# SERVICE BULLETIN

M-910

## EVOLUTION 1100cc SPORTSTERS VACUUM OPERATED ELECTRIC SWITCH

Figure 1. Relocating Ground Wire Mount

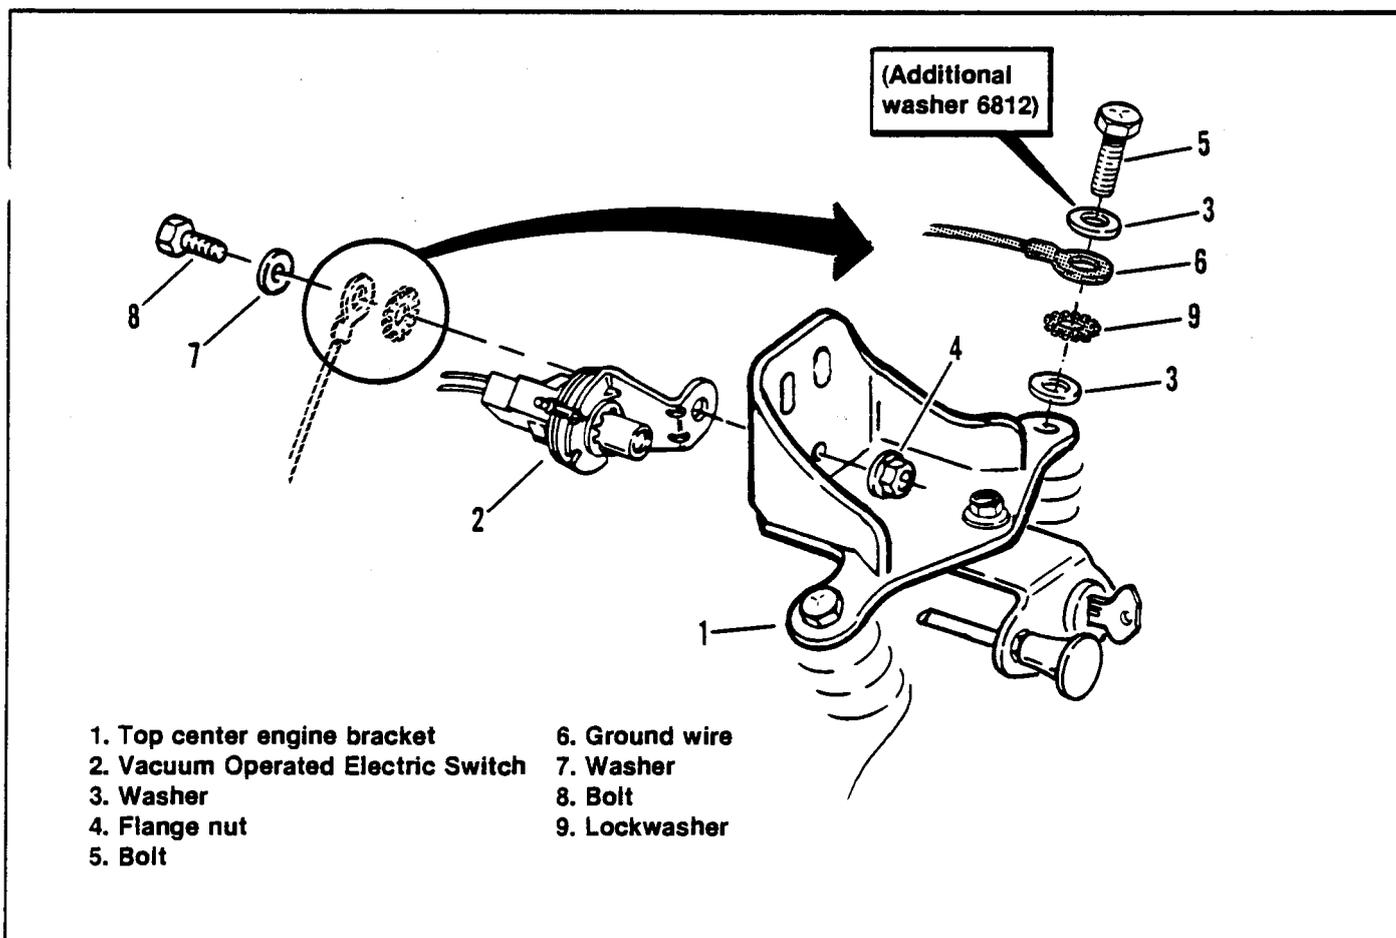
On 1986 1100cc Sportsters, a mid-year production change has rerouted the Vacuum Operated Electric Switch, ground wire, to a different mounting location. The new location for anchoring the ground wire improves electrical conduction to ground. All 1100cc vehicles produced after VIN 1HD1CAN10GY115548 have this change. Motorcycles with an earlier VIN may also require this change. Improper grounding of the Vacuum Operated Electric Switch will cause erratic idle, poor low speed operation

or difficulty in locating the ignition timing mark.

1. Remove V.O.E.S. mounting bolt (8), washer (7) and nut (4).
2. Disconnect V.O.E.S. ground wire (6) and washer (9) from bolt (8). Attach V.O.E.S. switch to bracket (1) with bolt (8) washer (7) and nut (4). Tighten nut (4) to a torque of 20 ft lbs.

**Check to be sure V.O.E.S. does not contact engine rocker box. Normal engine vibration and heat could damage switch.**

3. Remove the rear cylinder bracket bolt (5) and washer (3).
4. Place an additional washer HD Part No. 6812 on bolt (5), followed by ground wire (6), washer (9) and original washer (3). Thread bolt (5) into cylinder and

tighten to a torque of 21-27 ft lbs.

**Check to be sure ground wire is not contacting engine rocker box. Normal engine vibration and heat could damage switch wire.**
